DESIGN PH	DRAWN BY PH	DART AEROSPACE LTD HAWKESBURY, ONTARIO, CANADA	
CHECKED [Signature]	APPROVED [Signature]	DRAWING NO. DSI 9346	REV. C SHEET 1 OF 1
DATE 06.11.20		TITLE DEVIATION ON D206-667	SCALE NTS
A	06.08.08	NEW ISSUE	
B	06.10.10	ADD B28679, B28682, B28683	
C	06.11.20	ADD B29261

DART SERVICE INSTRUCTION

TO AMEND INSTALLATION INSTRUCTIONS IIN-D206-667 REV. C

FIGURE 1 - INSTALLATION OF DART CROSSTUBES ON BHT/AAI SKIDTUBE

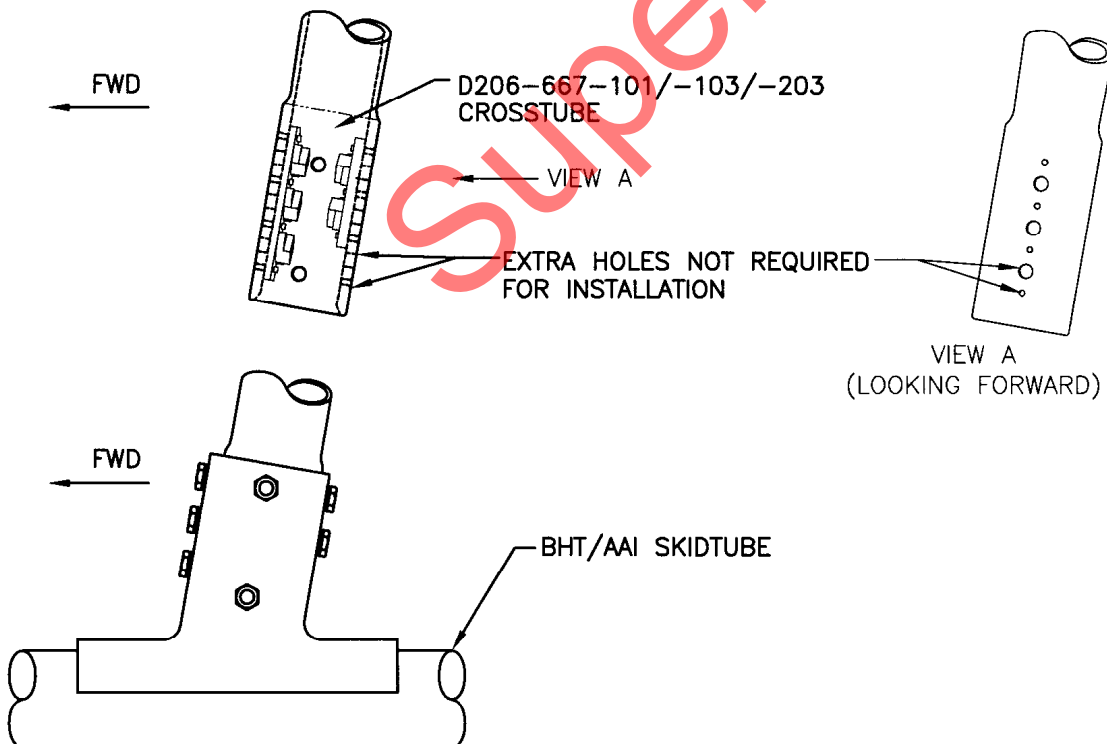
THE FOLLOWING D206-667-101/-103/-203 CROSSTUBES HAVE EXTRA HOLES DRILLED ON THE AFT SIDE OF THE CUFFS. THIS HOLE IS NOT REQUIRED FOR INSTALLATION OF DART CROSSTUBES ONTO BHT/AAI SKIDTUBES AS SHOWN IN FIGURE 1.

CUSTOMERS RECEIVING CROSSTUBES AT CHG 002 PRIOR TO 06.08.08 SHOULD CONTACT DART FOR DISPOSITION IF INSTALLING THE DART CROSSTUBES ONTO BHT/AAI SKIDTUBES PER IIN-D206-667 REV. C.

CUSTOMERS RECEIVING CROSSTUBES AT CHG 002 PRIOR TO 06.08.08 TO BE INSTALLED WITH DART SKIDTUBES MAY FIND THAT THE SUPPORTS HAVE BEEN INSTALLED BACKWARDS. THE SUPPORTS SHOULD BE REMOVED AND RE-INSTALLED PER ICA-D206-667.
